1. TITLE (Class, Function, Type, etc.) <b>Component Package, LCC-18, Ceramic Crack</b>		2. DOCUMENT NUMBER <b>FV5-A-07-01B</b>
		3. DATE (DD-MMM-YY) <b>01 August 2007</b>

4. MANUFACTURER AND ADDRESS <b>International Rectifier Aerospace and Defense 204 Crawford Street Leominster, MA 01453</b>	5. PART NUMBER <b>See Document</b>	6. NATIONAL STOCK NUMBER <b>See Database</b>

## LCC-18 Ceramic Micro-crack Technical Review

Picture showing Green Dot and location

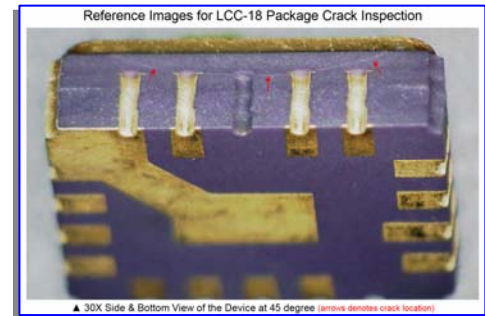
5. Beginning 6/20/2007, material returned to IR for micro-crack verification will be marked to indicate acceptance. IR will add a Green Dot marking to those returned devices that have passed 100% inspection for sidewall micro-crack. LCC-18 product returned to the field with the Green Dot will provide positive identification of the inspection for micro-crack and acceptability thereof. Packages inspected that are found to exhibit a micro-crack will be segregated for scrap disposition. See picture below for Green Dot reference.
